MEMORANDUM

RE: Parking Departure Correction Response

Correction Response: Vehicular Parking Departure

Ground Floor Program Priorities

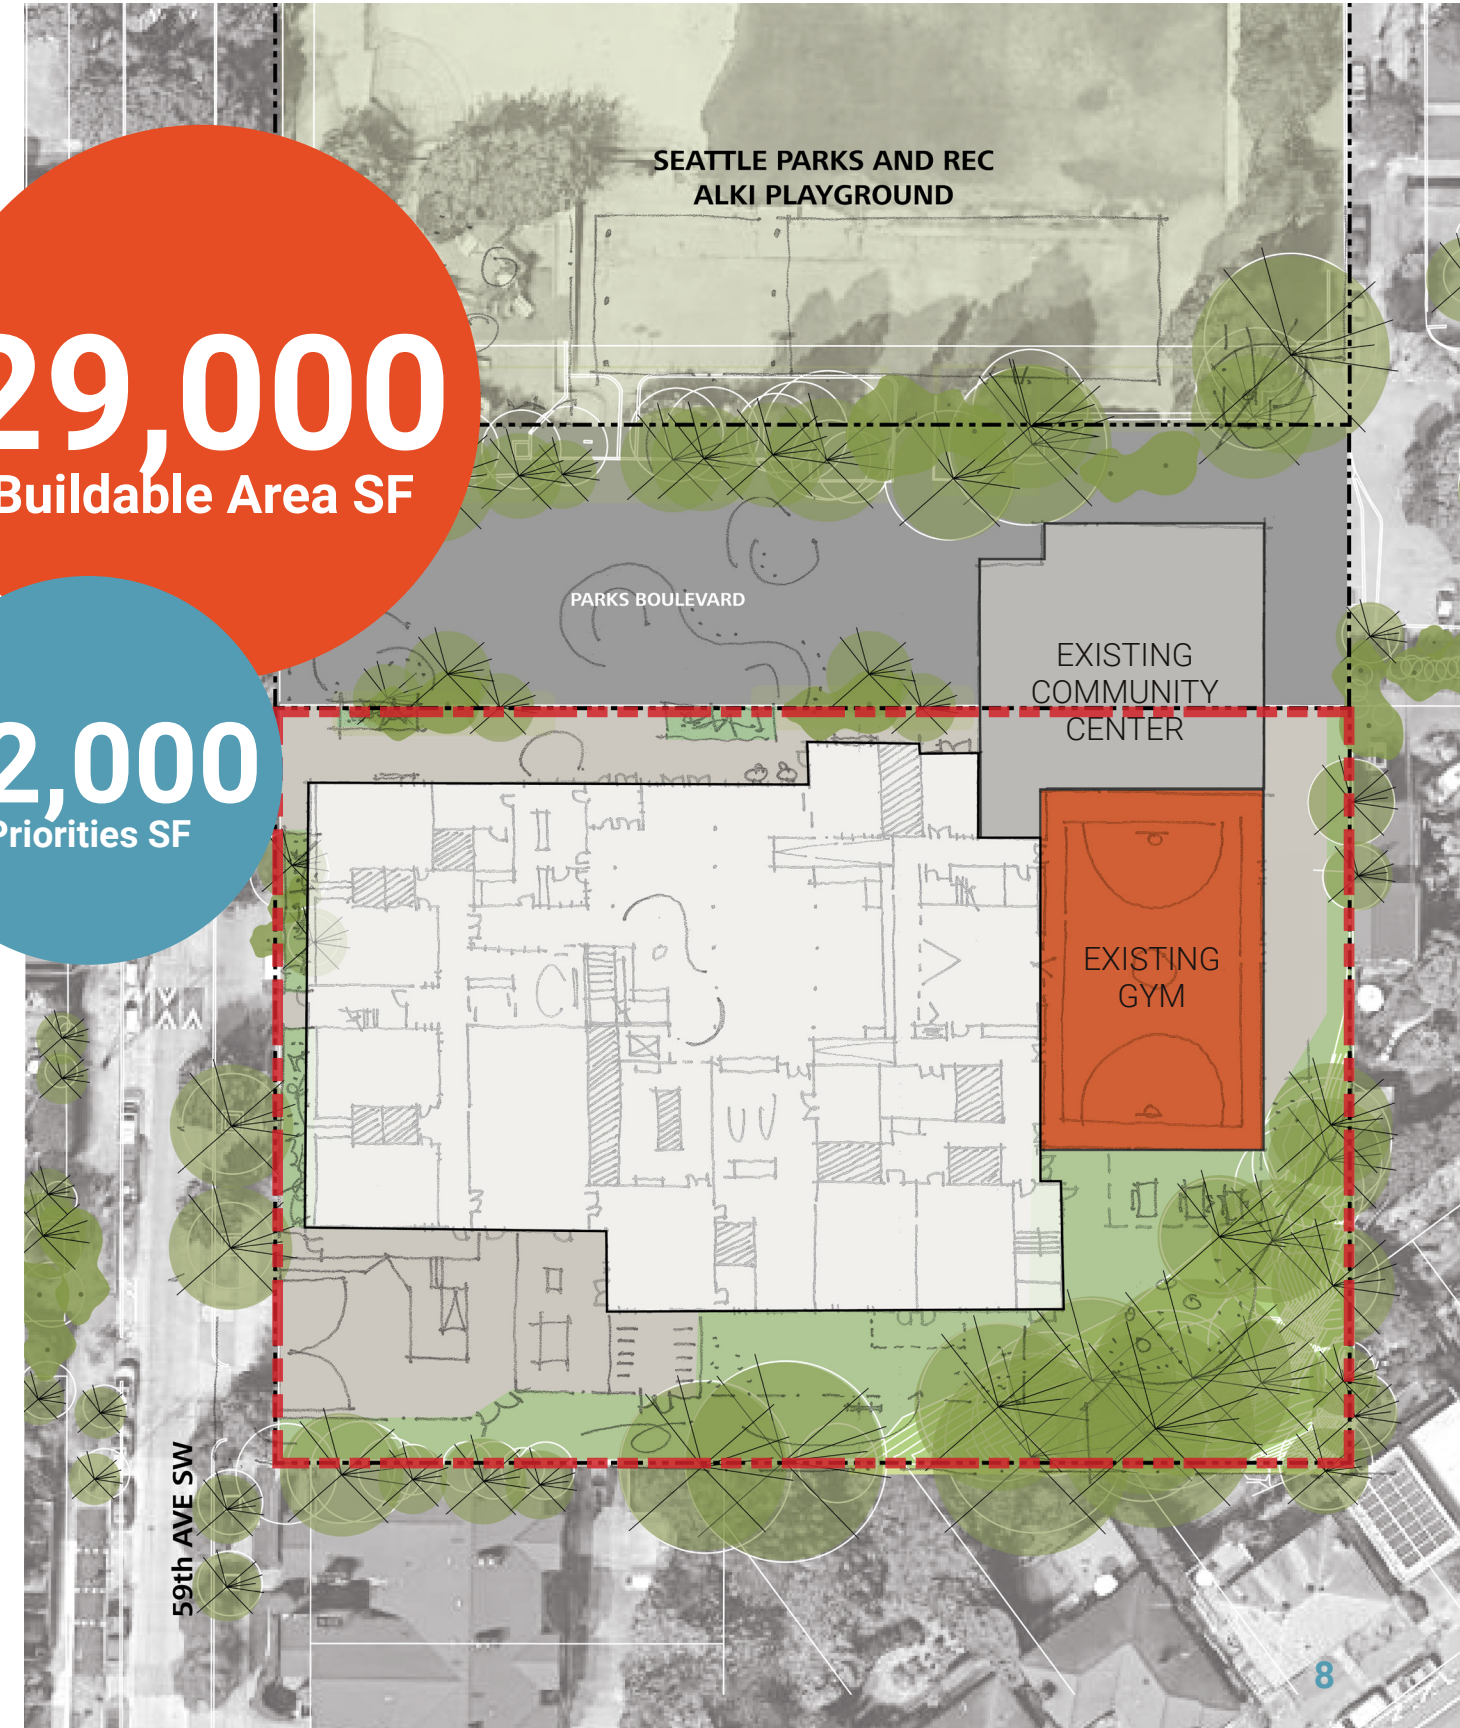
Ground floor requirements specific to elementary schools drive a minimum building footprint size. No matter the student capacity of the replacement school, the footprint of the new school building is effectively set and cannot be reduced significantly to provide code-required parking.

On-site Code Compliant Parking

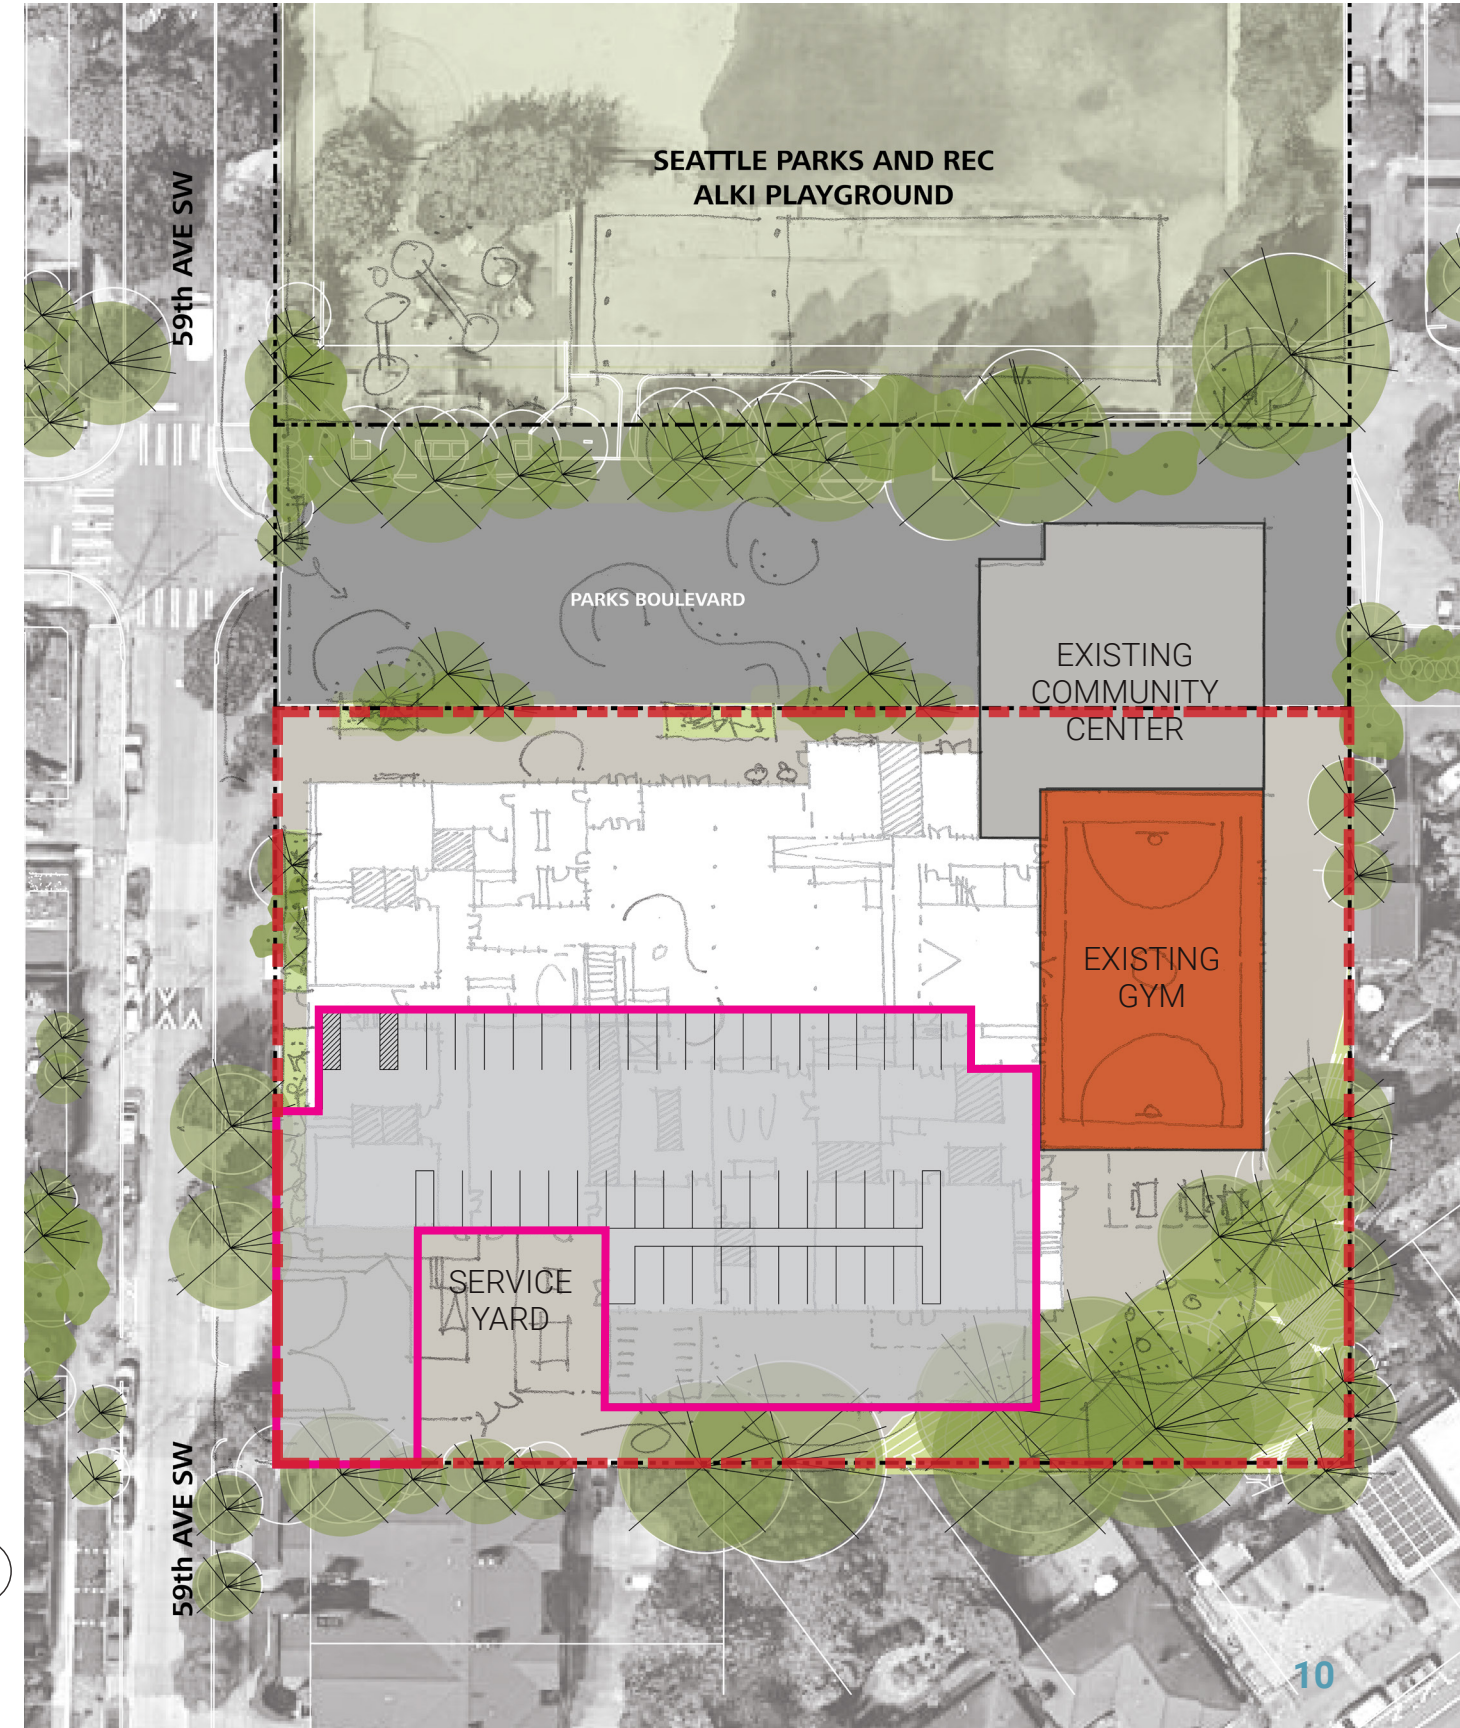
Ground floor requirements specific to elementary schools drive a minimum building footprint size, incompatible with space requirement for 48 surface parking spaces. If all code required parking were provided, a parking lot sized at half the buildable area would be required, as illustrated in the graphic.

Additionally, the School Traffic Safety Committee encouraged the project to minimize the site area dedicated to private vehicles for multiple reasons: improved pedestrian safety, improved air quality, noise reduction, and equity with alternative forms of transportation.

Correction Response: Prior Site Design

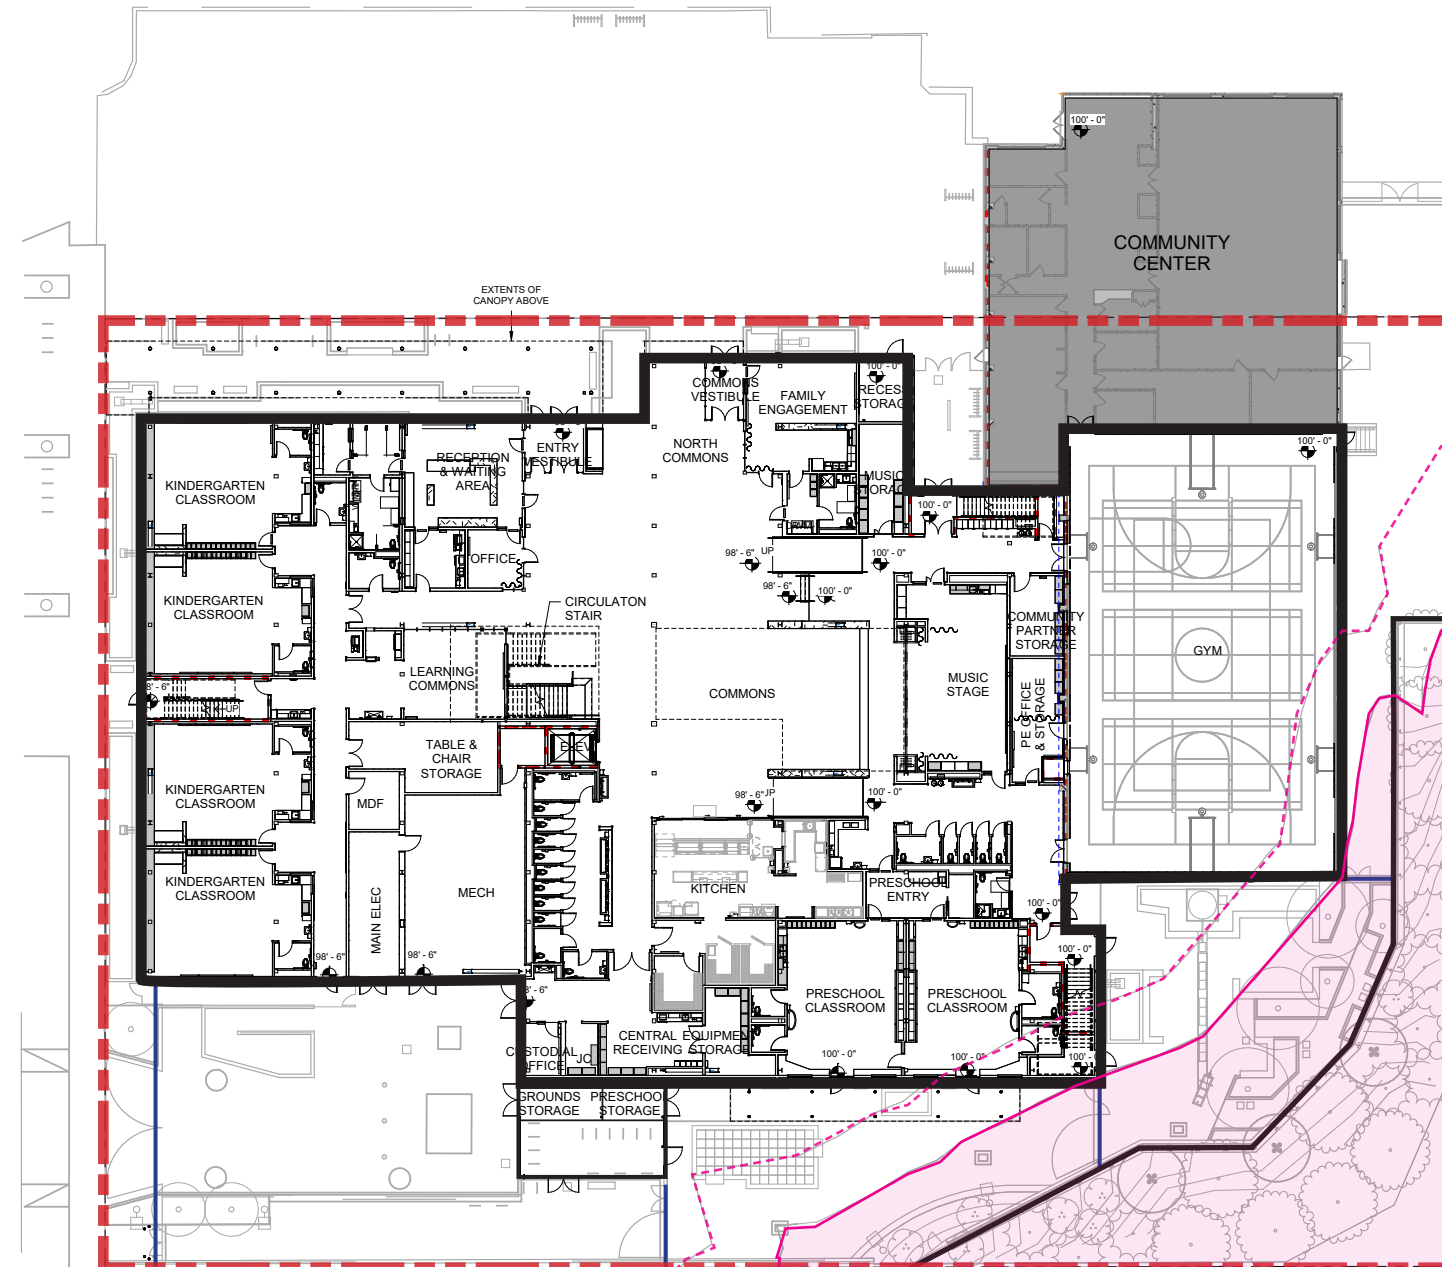
The site design as previously proposed with zero parking spaces is illustrated to the right.

Based on the necessary footprint of the building to accommodate the educational needs of the student population, there were limited options for providing on-site parking outside of removing critical educational programming.

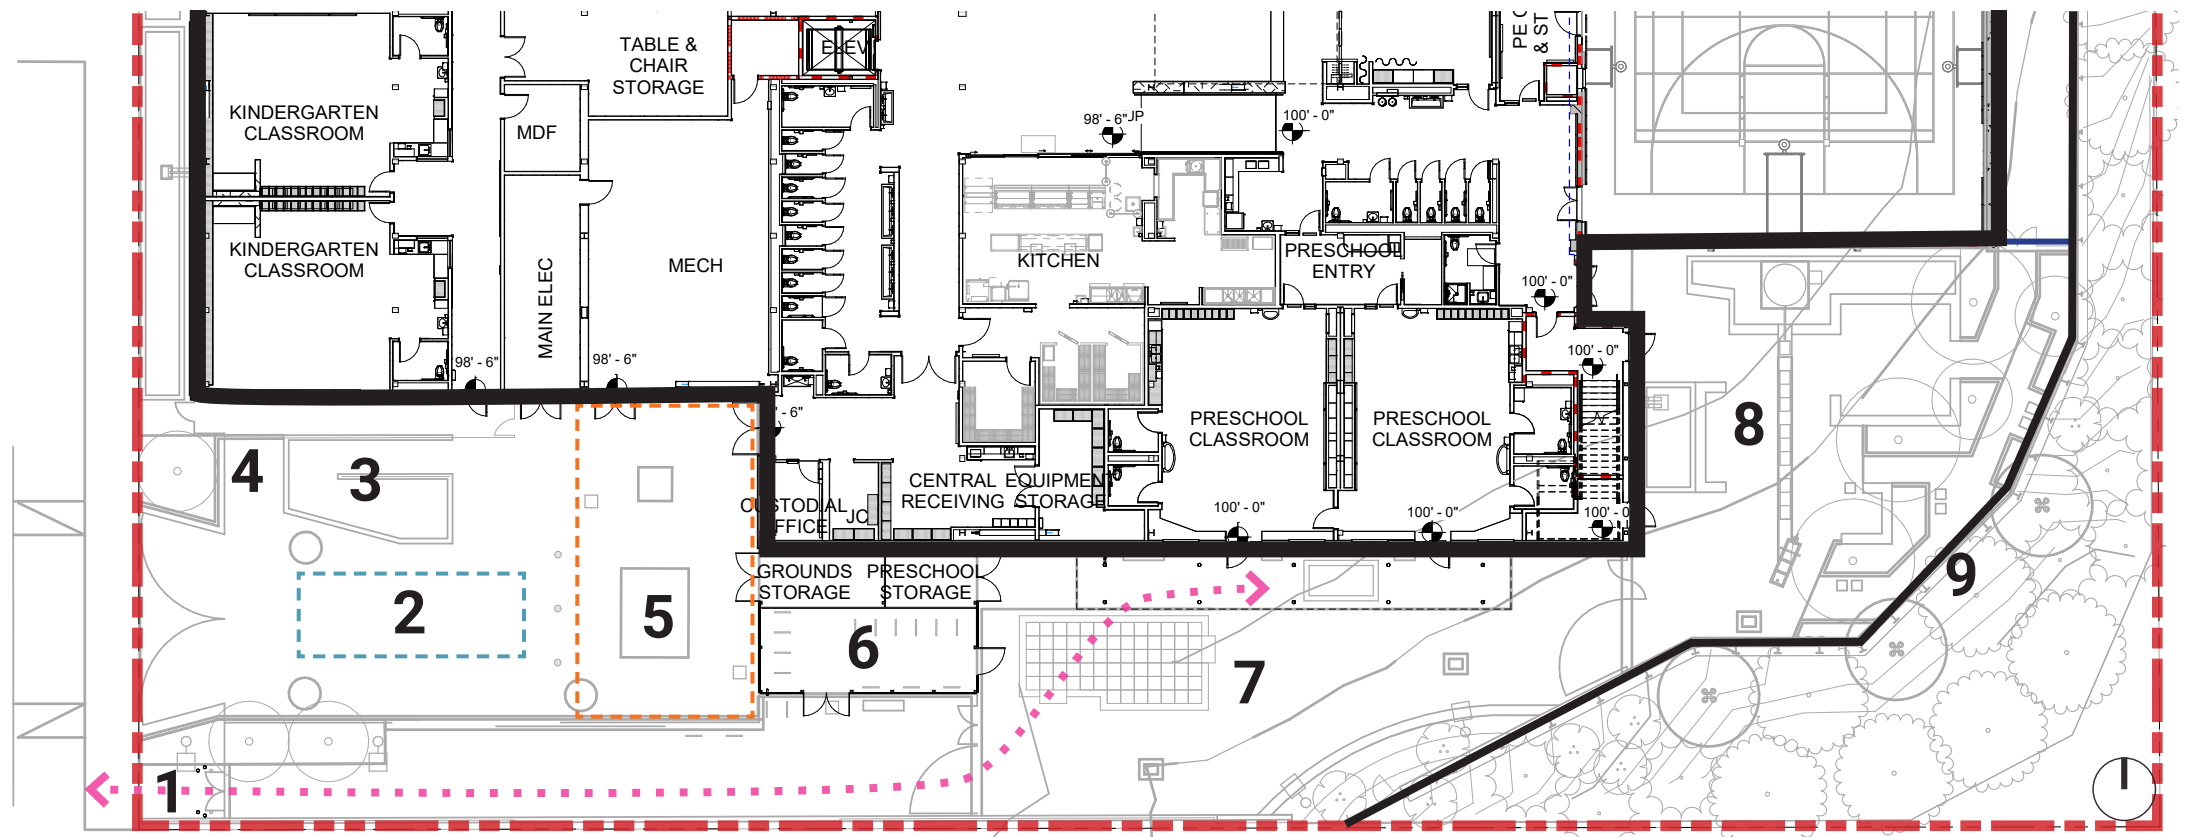
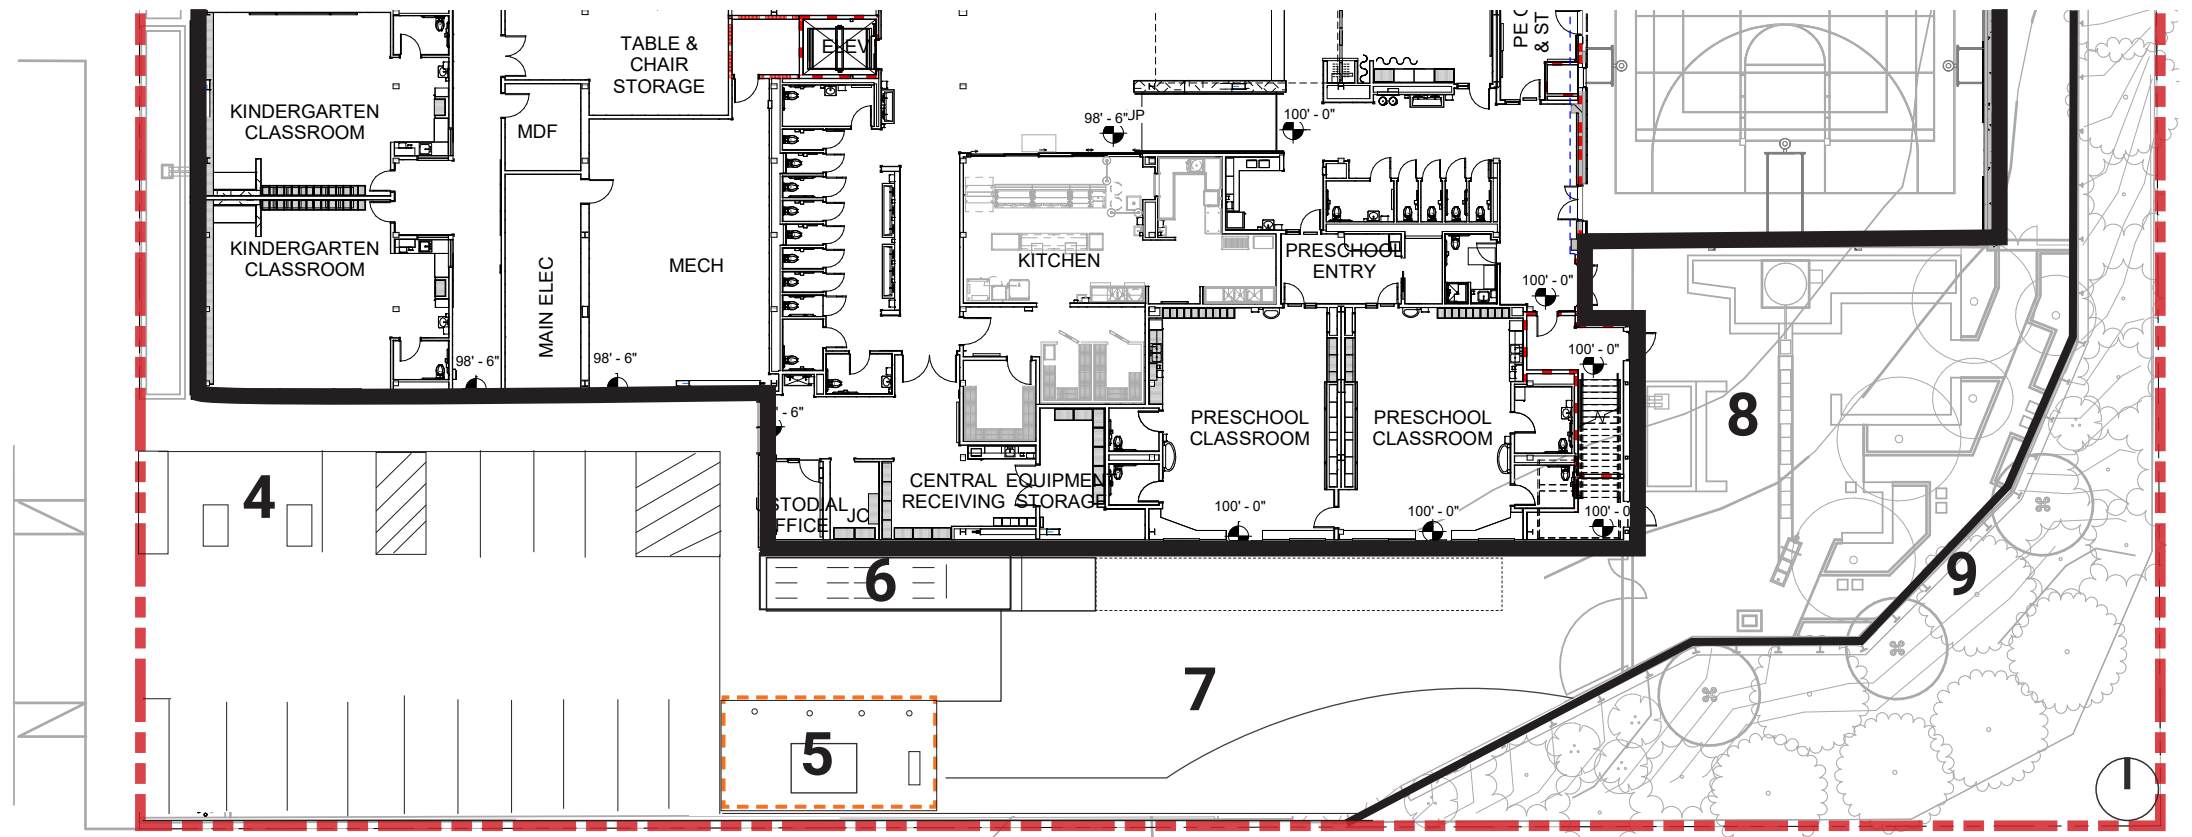
As each element of the school is necessary to accomplish the educational goals of SPS, the team explored how to retain only the critical elements of the school while reconfiguring or removing features that are important and desired, but not critical to the functioning of the school.

Of the nine site elements identified to the right, items 1 through 3 were removed from the project, items 4 through 7 were reconfigured, and items 8 and 9 were maintained as previously designed.

This redesign sacrificed those elements that are desired for the functioning of the school, such as better loading, storage, and separated pedestrian path and left only those architectural elements that were necessary to meet educational goals.
